PRODUCT CHANGE NOTIFICATION

Product Identification: 0ZLJXXXXXXXX,0ZLKXXXXXXXX,0ZLMXXXXXXXX

PCN Number: PCN-F260009

Reason for Change (s): Improve solder performance

Marking example:

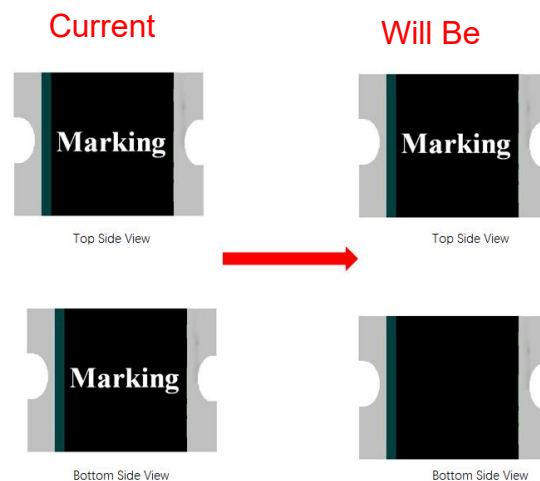
0ZLJ,0ZLK, 0ZLM Series change the product marking from "double-sided marking" to "single-sided marking". The no-marking side is intended to improve soldering performance.
